## Service Bulletin No. 399

MODEL	J4500 Series	Field Change Program	SECTION/GROUP 7-Electrical	Oct. 2, 2013		
WABCO ESC/ ABS ECU						
CONDITIONS

Figure 1.

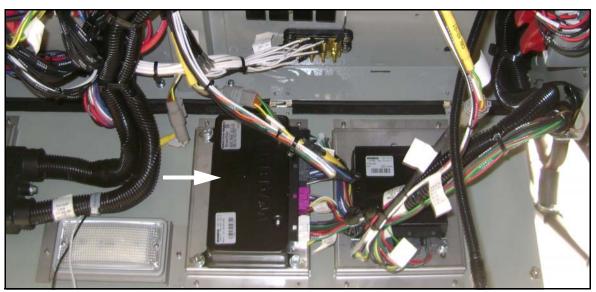
Motor Coach Industries ("MCI") has become aware that the incorrect electronic control unit (ECU), which controls the antilock braking system (ABS) on the trailing (tag) axle, was installed at the production plant.

An incorrect ECU on a coach equipped with a rear axle steering (RAS) tag axle could result in unnecessary yaw corrections by the electronic stability control (ESC) system at speeds below 20 mph. The operator may experience a small bump steer force at the steering wheel and minor jerking motion of the coach due to brief system application of the service brakes at one or more of the wheel ends.

- 1. Position the main disconnect rotary switch to the DOWN (OFF) position.
- 2. Chock both sides of the tires.
- 3. Open the curbside and roadside doors of baggage bay compartment #3.
- 4. Locate the rear electrical junction box mounted to the ceiling of baggage bay compartment #3. Release the rubber T-straps on the electrical junction box closing panel.
- 5. Locate the ECU on the hinged electrical junction box closing panel (refer to Figure 1.).

- 6. Carefully disconnect the four (4) harnesses from the ECU.
- 7. Remove and retain the mounting hardware from the ECU. Remove and retain the ECU for submittal back to MCI.
